**Attachment 18  
NRC3-10-0006**

**Response to RAI Letter No. 17  
(eRAI Tracking No. 4007)**

**RAI Question No. 02.05.01-30**

**RAI Question No. 02.05.02-02**

Figure 1 – Map Showing Modified Bechtel Sources

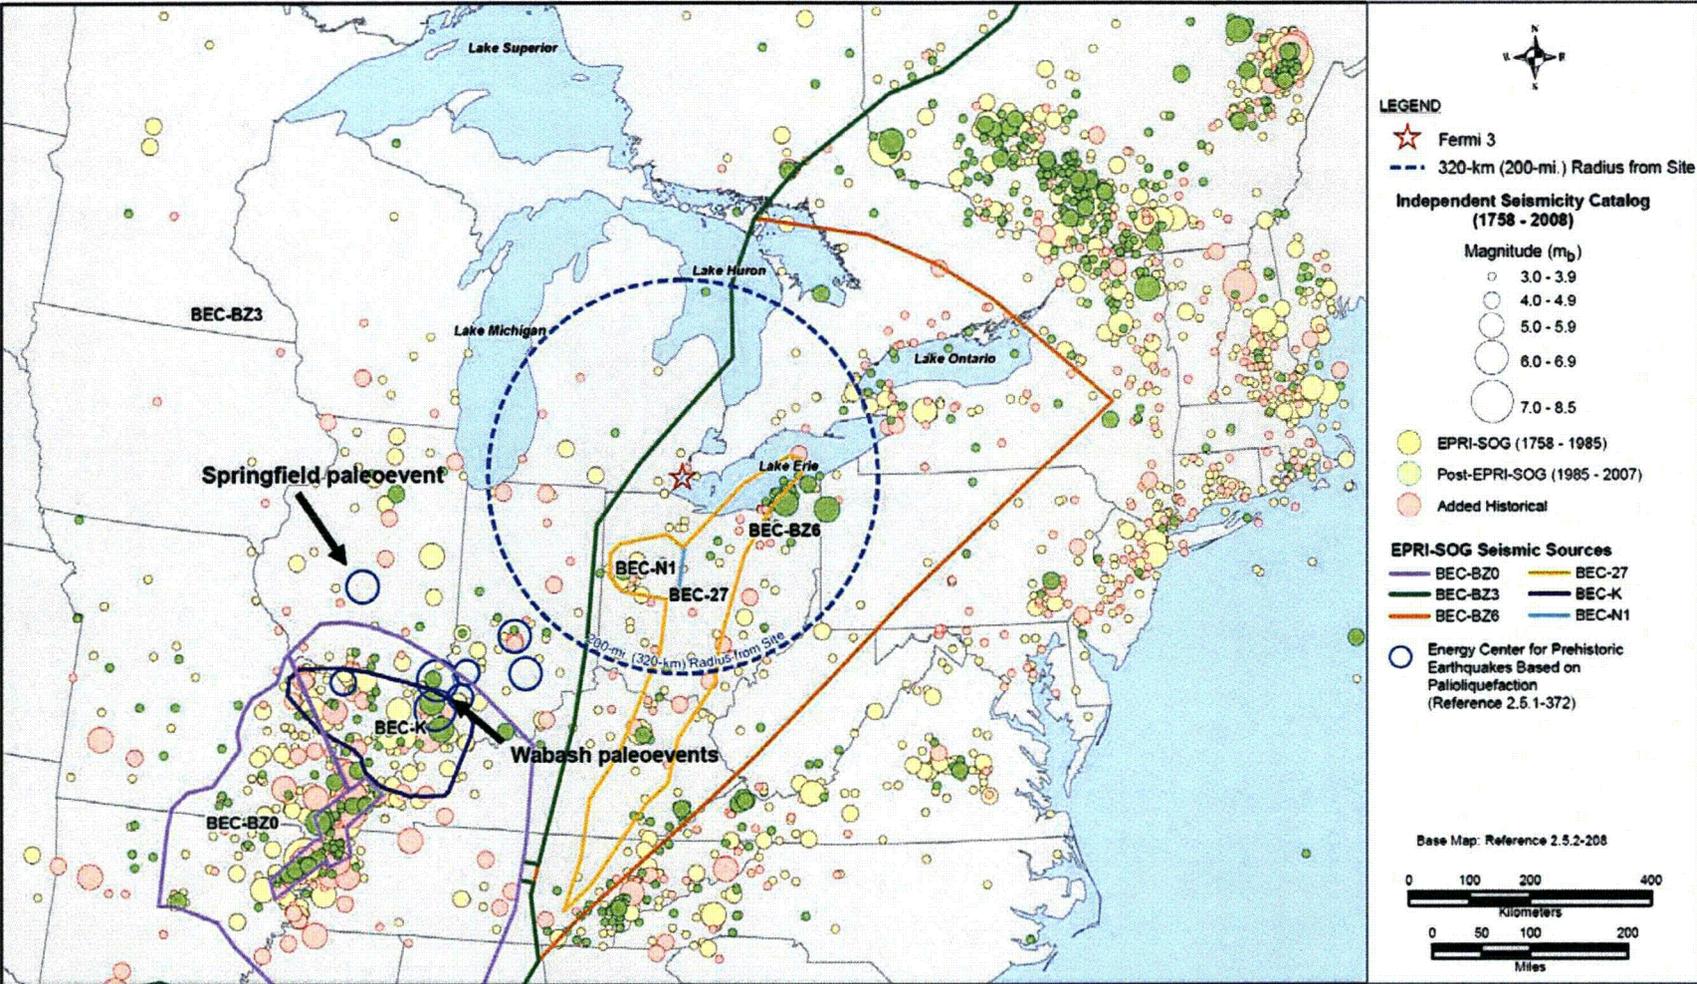
*FSAR Section 2.5.2.4 includes an update of the EPRI SOG seismic source parameters (specifically, maximum magnitudes) based on the latest earthquake information. Please explain why the maximum magnitudes for the Bechtel BZ3 source were updated but the Law Engineering source 114 maximum magnitudes were not updated. Please provide a detailed description of the SSHAC procedure used in revising the EPRI/SOG seismic source parameters, including the maximum magnitude, probability of activity and others. Describe how you integrated expert opinions, especially conflicting opinions, and how you incorporated the informed community consensus into the revised seismic source model. In addition, discuss how you applied regional paleoseismic data to the source updates.*

Finally, the updated earthquake catalog was used to obtain the largest earthquake observed in each of the EPRI-SOG seismic sources. The 1986  $m_b$  5.0 and the 1998  $m_b$  5.2 earthquakes in Ohio are larger than the minimum maximum magnitude assigned by the Law Engineering team to their Source LAW-112 and by the Woodward-Clyde team to their background source for the Fermi 3 site. Accordingly, the maximum magnitude distributions for these two sources were modified to account for these post-EPRI-SOG earthquakes using the approach applied by each team for assessing maximum magnitude.

Figure 1 – Iseismal Map of the January 31, 1986, Earthquake (FSAR Reference 2.5.1-228).

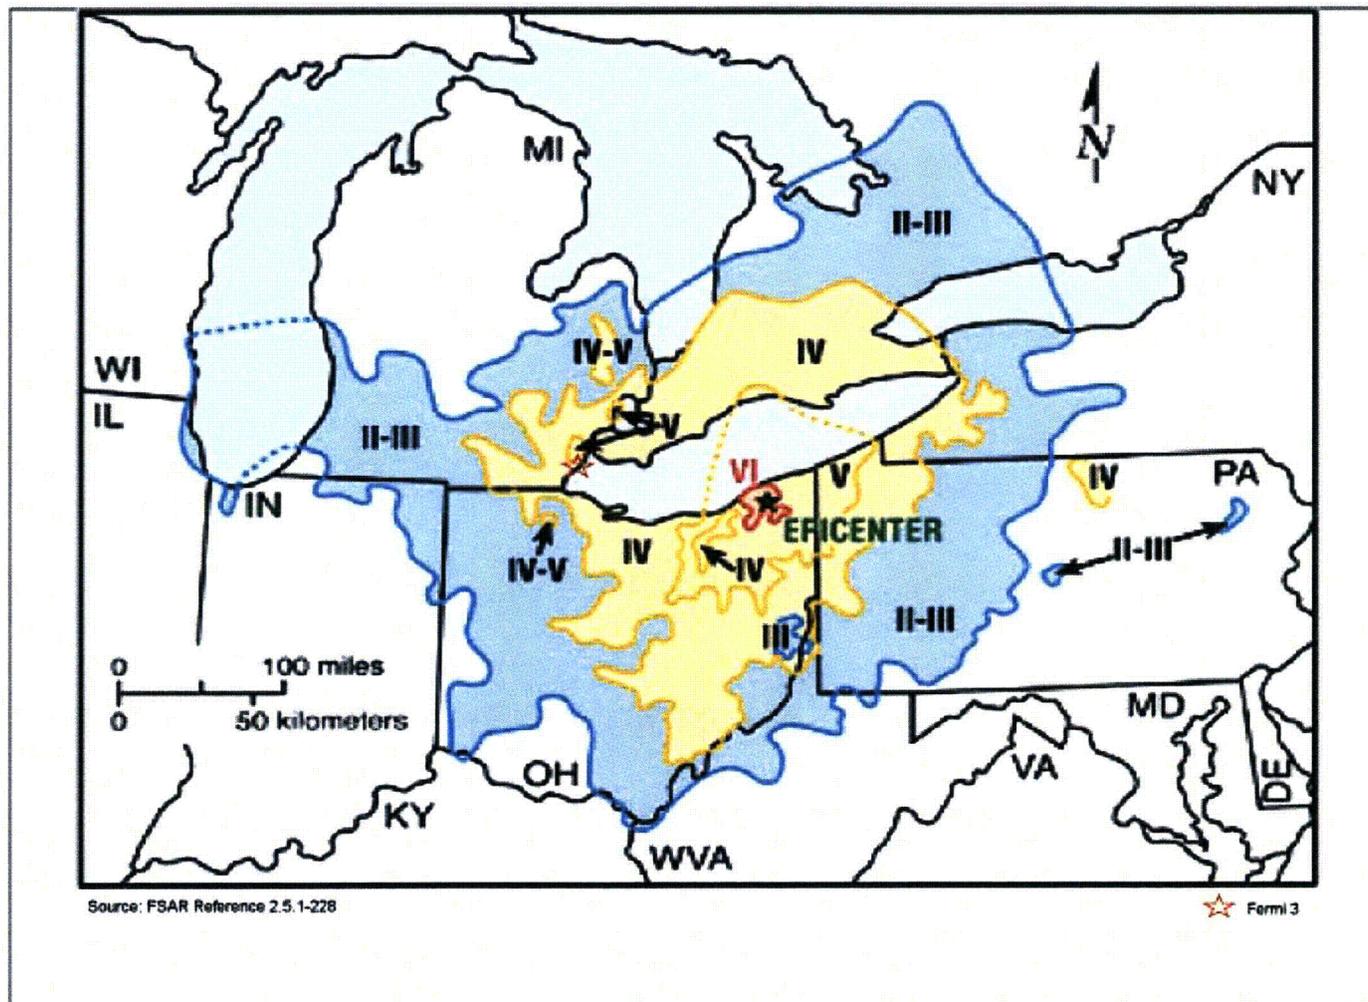
The statement that the January 31, 1986, earthquake produced Modified Mercalli Intensity (MMI) IV-V shaking at the Fermi 3 site is based on an isoseismal map presented by Hansen (FSAR Reference 2.5.1-228) as shown on Figure 1. The statement that the July 12, 1986, earthquake produced MMI III shaking at the Fermi 3 site is also based on an isoseismal map presented by Hansen (FSAR Reference 2.5.1-229) as shown on Figure 2. These two isoseismal maps were taken from Stover and Brewer (Reference 1), which include the locations of felt reports for both events, as determined from surveys. Attached Figures 3 and 4 contain Stover and Brewer's (Reference 1) original isoseismal maps with intensity data for the January 31 and July 12, 1986, earthquakes, respectively. Felt earthquake intensity reports are plotted as a Roman numeral of the intensity, and earthquakes reported not to have been felt are plotted as an open circle. A felt report for the town of Monroe, Michigan, provides evidence for MMI IV shaking during the January 31, 1986, earthquake. The closest felt reports to the Fermi 3 site during the July 12, 1986, earthquake indicate that the event was not felt; however intensity III reports were obtained from the towns of Dundee and Gross Ile, located 31.5 km (19.6 mi) and 21 km (13 mi), respectively, from the Fermi 3 site. The Earthquake Intensity Database maintained by NOAA does not contain intensity data for Michigan after 1983 (Reference 2).

**Figure 1. Map Showing the Aerial and Field Reconnaissance Routes and Key Field Localities**

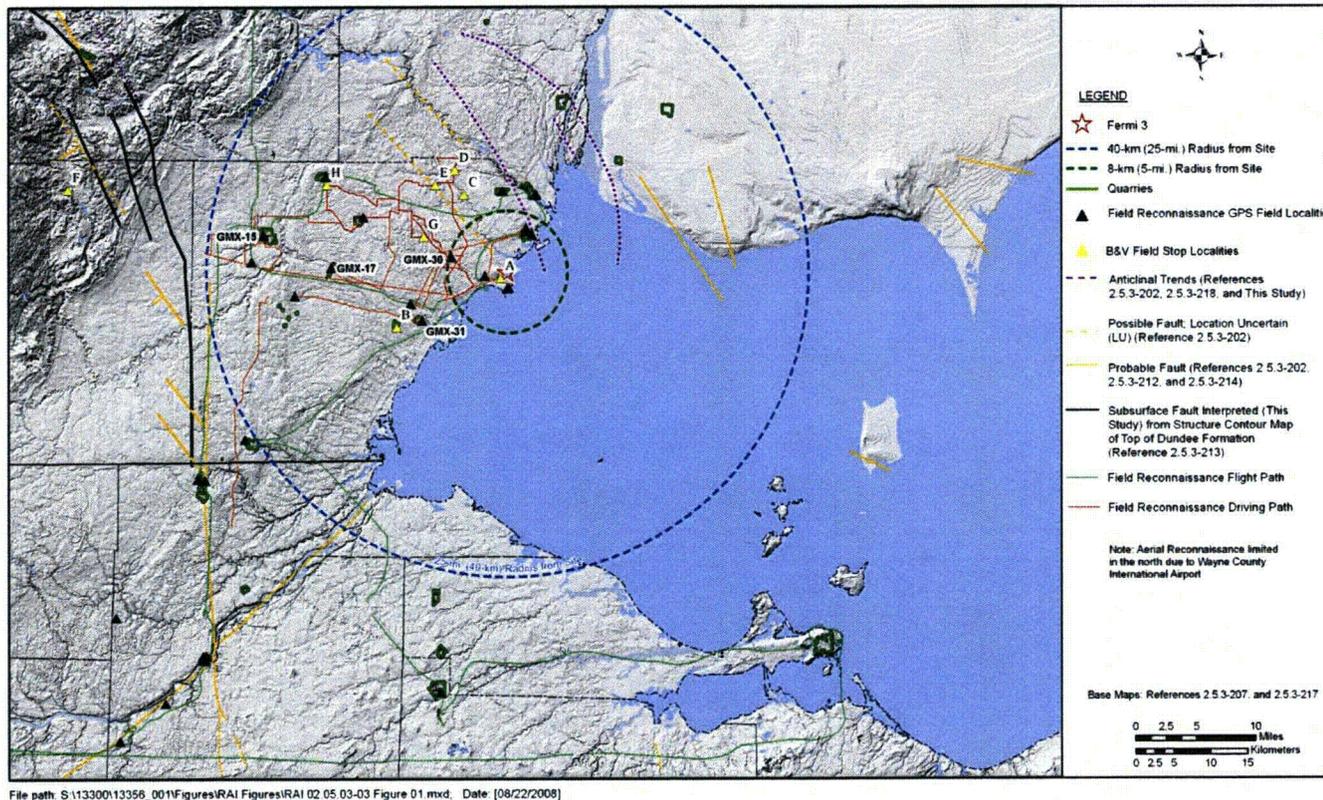
Quaternary surficial geologic units exposed in the Fermi 3 site vicinity (40 km [25 mi.] radius) consist primarily of till of Wisconsinan age overlain by a thin mantle of lacustrine and eolian sands or locally thicker beach-dune ridge deposits formed along late glacial lake shorelines (FSAR Figure 2.5.1-231). Publications and reports describing glacial lake deposits and shoreline features (e.g., References 2.5.1-297 and 2.5.1-391), as well as electronic data for Quaternary map units (e.g., References 2.5.1-450, 2.5.1-451, and 2.5.1-452) and soil maps (Reference 2.5.1-405), were compiled and reviewed, providing key data sets for evaluating the surficial stratigraphy and geomorphology in the site vicinity. Field and aerial reconnaissances were conducted in 2007 and 2009 to further evaluate the stratigraphy in the site vicinity. The reconnaissance routes and key field stop localities are shown on Figure 1.

Figure 1 Possible Early Holocene Position of Former Detroit River Channel and Fan in Western Lake Erie

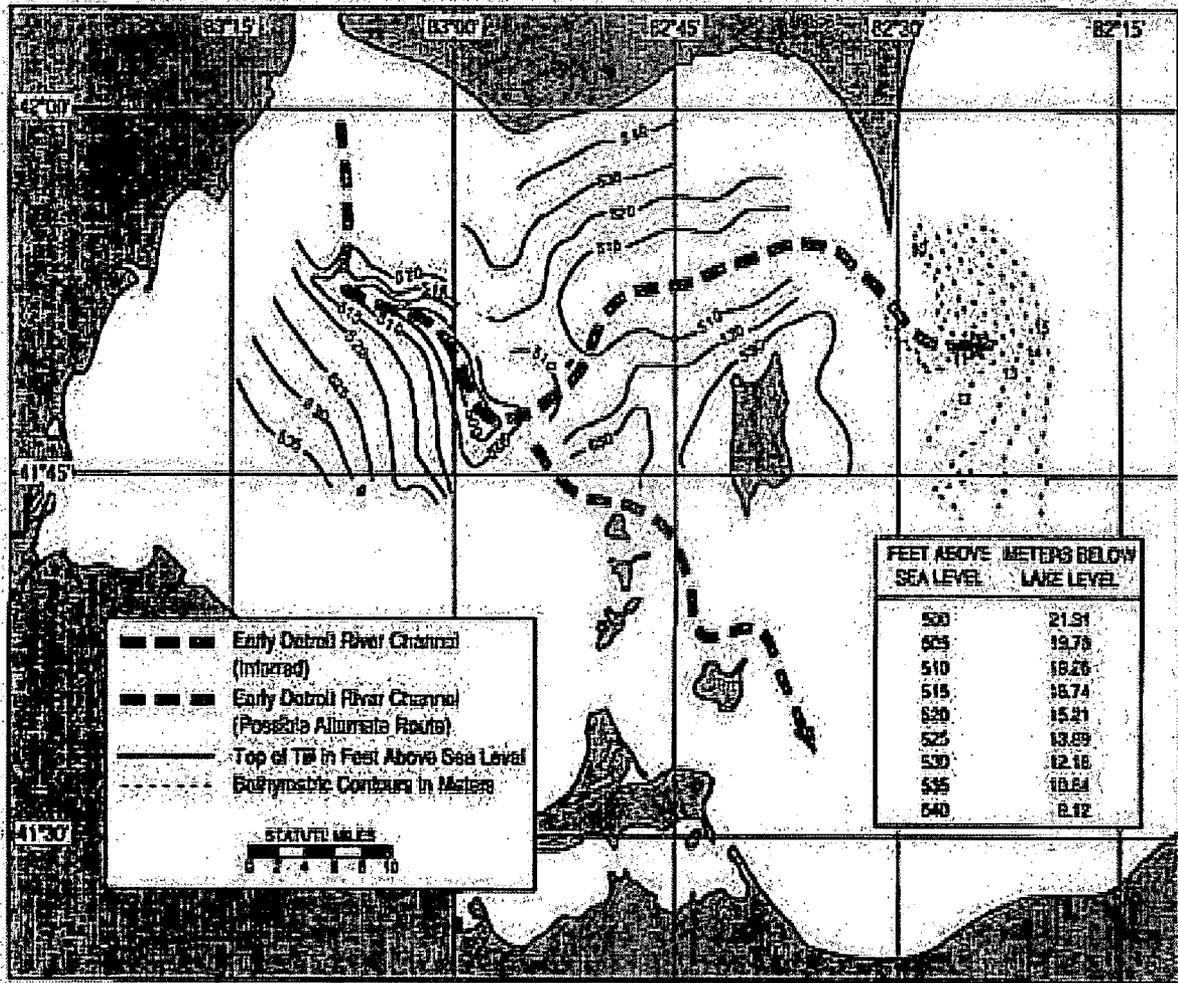
- If the Point Pelee Fan is a relict shoreline feature, it may be a former shoreline delta of the Detroit River that formed following the opening of the Port Huron outlet about 4,000 years BP (Figure 1). During this time the newly formed Detroit River was eroding its channel and bringing a heavy load of sediment into Lake Erie. An alternative interpretation for formation of the Point Pelee Fan is that strong west-to-east currents have swept around the end of the Point Pelee Ridge and carried sediments eastward.

Figure 2 Seismic Data Quality and Track Chart, Western Lake Erie

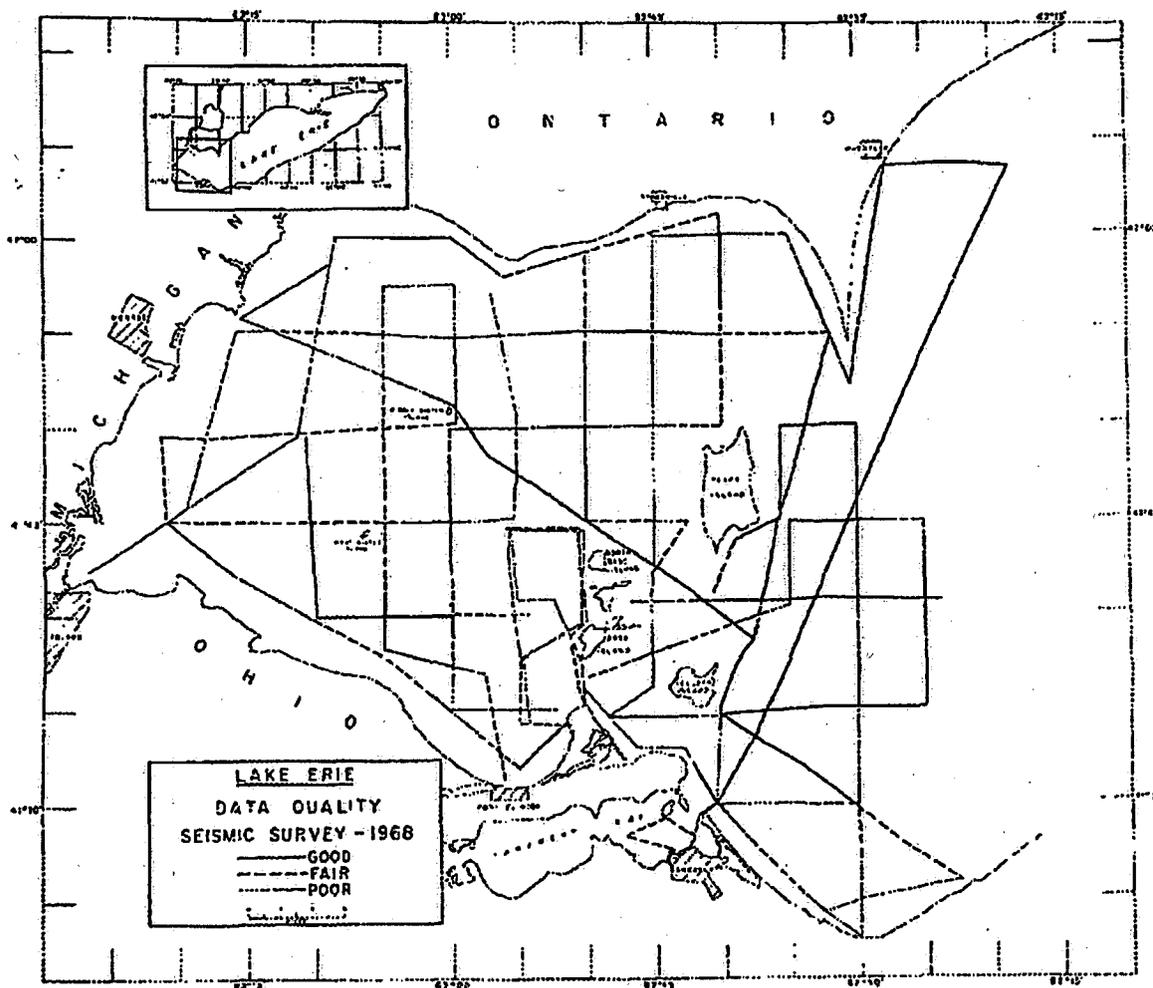
The results of the study are presented in a series of figures, including ones showing seismic data quality and track chart (Figure 2); elevation of top of till (Figure 3); thickness of unconsolidated sediment overlying bedrock (Figure 4), bedrock surface topography (Figure 5); and inferred preglacial drainage (Figure 6). Information from all wells bored for oil and gas exploration in the Canadian offshore region, as well as extensive borings by the coauthors of the paper, was used to develop Figures 3, 4, and 5. Maximum bedrock relief is 67 m (220 ft), and sediment thickness ranges from zero to 36.6 m (120 ft). The major areas of high relief (Point Pelee and the Bass Islands) are clearly related to erosion-resistant rock formations.

Figure 3 Elevation of Top of Till Underlying Western Lake Erie

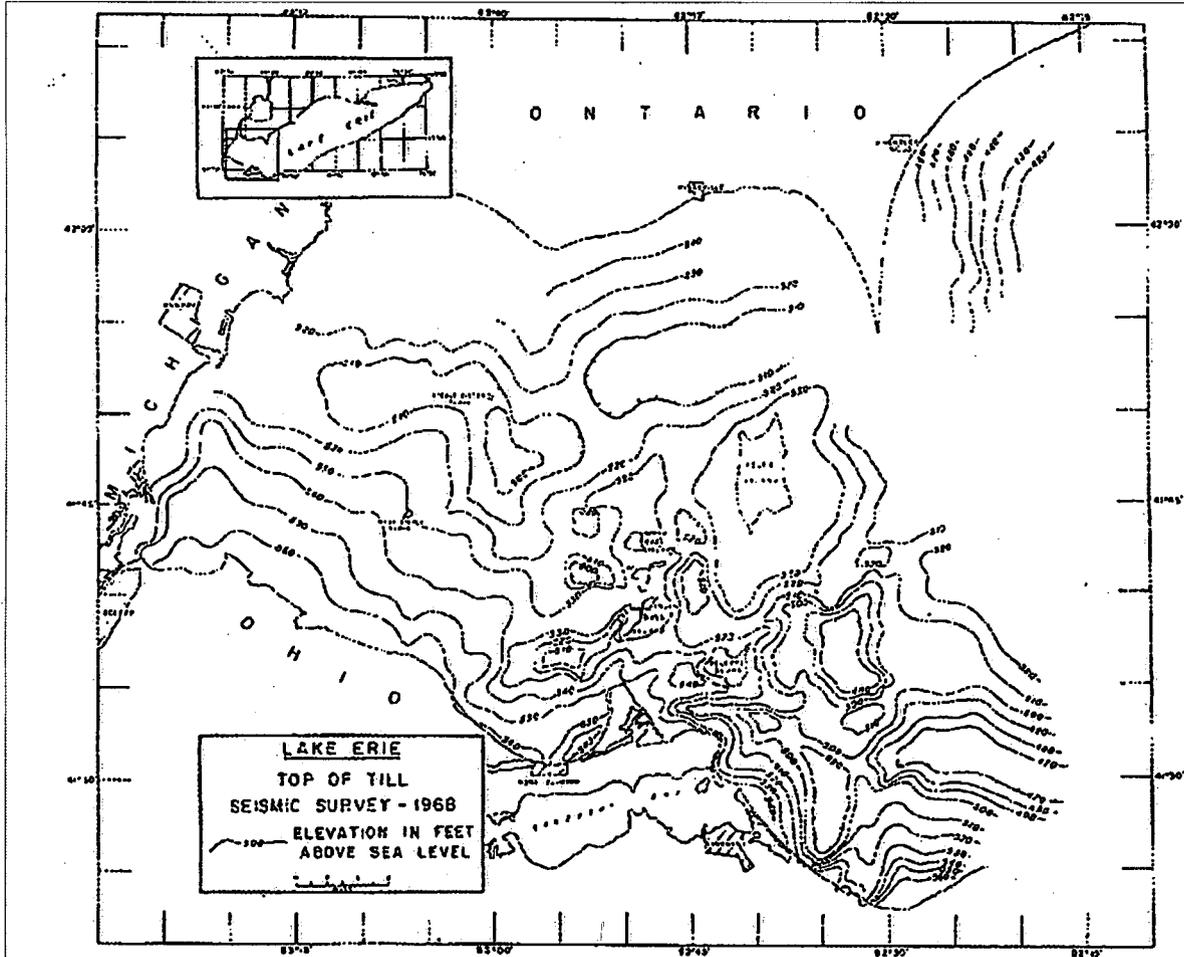
The only horizon that could be traced over significant areas in the western basin was inferred to represent the top of till (Figure 3). This surface reflects the general pattern of late glacial and postglacial drainage during low level phases of Lake Erie. Over the greater part of the survey area, the combined results of glacial and lacustrine processes have been one of deposition that filled pre-existing lows, and topographic smoothing.

Figure 4 Thickness of Unconsolidated Sediments Overlying Bedrock, Western Lake Erie

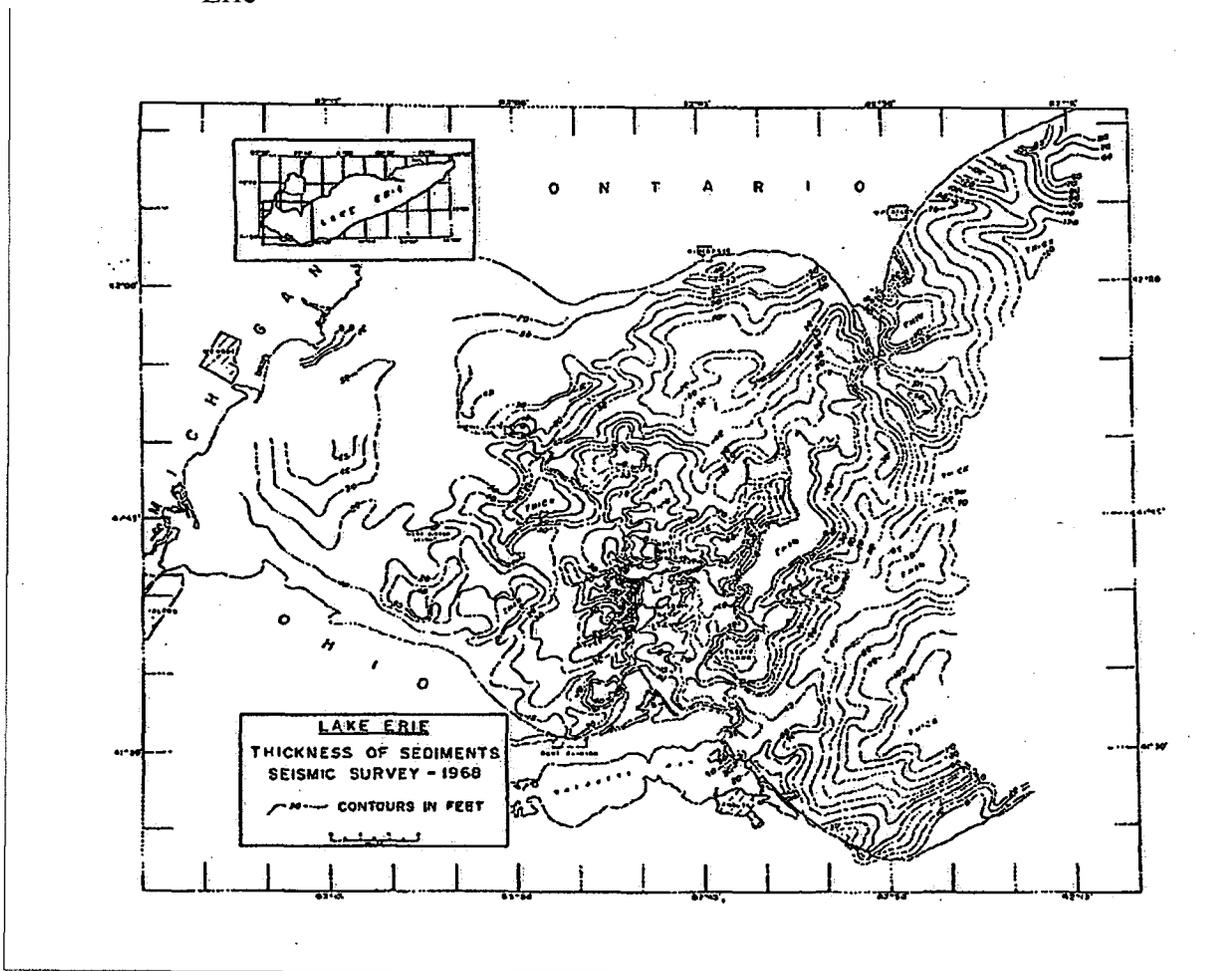
An eastward-flowing preglacial drainage system shown on Figure 6 was inferred from the thickness of unconsolidated sediment (Figure 4) and resulting bedrock topography map (Figure 5). This interpretation is based on assumptions that ice scour probably deepened the valleys preferentially and created closed depressions, without significantly altering the drainage divides, and that no significant differential earth movements have occurred since preglacial time. Hobson et al. (Reference 2.5.1-496) conclude that the drainage pattern appears to be a subsequent stream system that developed by headward erosion along the strike of weak bedrock zones of arched, northward-plunging Paleozoic strata in the Findley arch.
